CENTER FOR NUCLEAR WASTE REGULATORY ANALYSES

NONCONFORMANCE REPORT

NCR No. 2003-01

Alloy 22 weld specimens CNWRA Drawing 20-06002-01-081-001 machined by Industrial Mechanical are not within the tolerances. Modifications to the dimensions specified on the drawing were necessary because the Alloy 22 plate supplied to Industrial Mechanical was bowed. Part of the bow was removed by pressing and part was removed by machining the plate surfaces. A detailed description of the non conformance items is provided below:

Alloy 22 Weld Specimen
CNWRA Drawing 20-06002-01-081-001
All Dimensions $\pm 0.005"$
unless otherwise specified
Detail A identified on Page 1

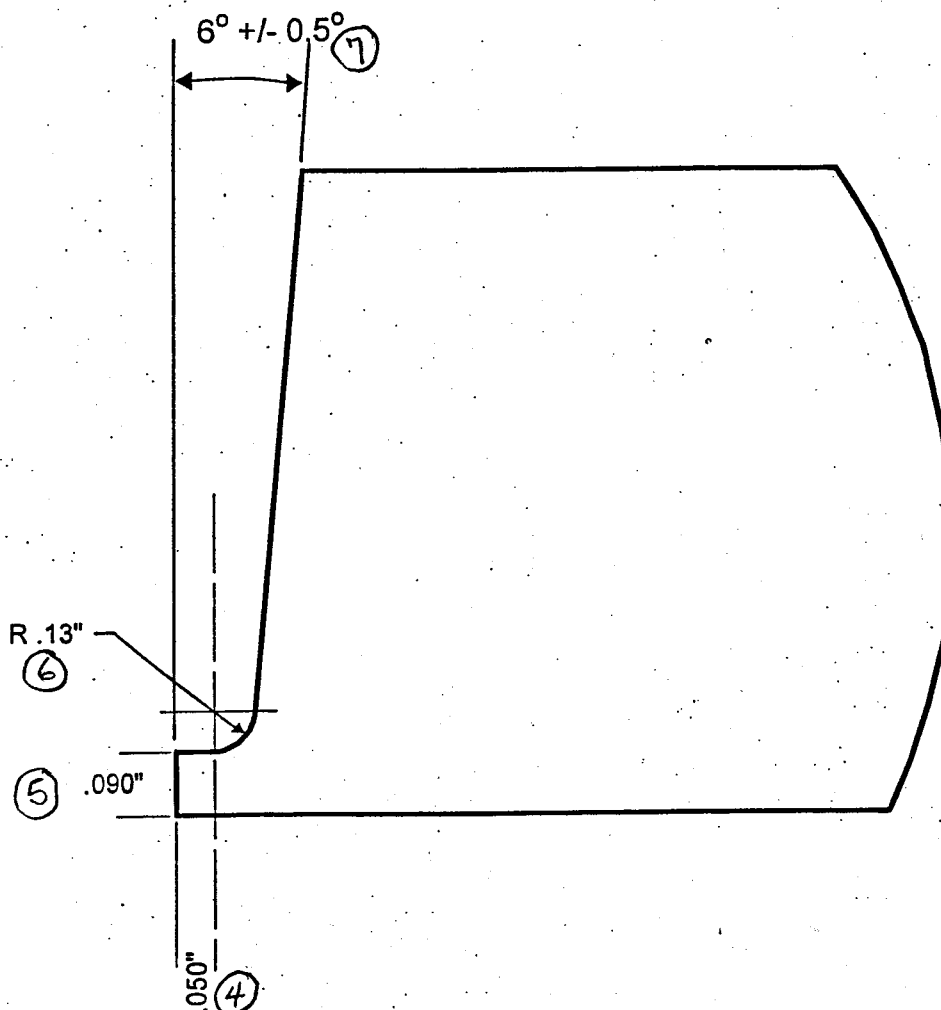
1. Thickness of machined specimens was reduced by 0.005 to 0.030" to remove bow in plate. Final thickness after machining has been provided in documentation provided by Industrial Mechanical. *(all 4 specimens)*
2. Plate C: The 0.090" land thickness measures 0.090 to 0.097"
3. Plate D: The 0.090" land thickness measures 0.093 to 0.100"

Accept specimens as is.

The variation in the thickness of the land will not affect weldability of the plate. Integrity of the weld joint will be assessed by non destructive examination including penetrant testing of the root pass and radiographic testing of the completed weld. .
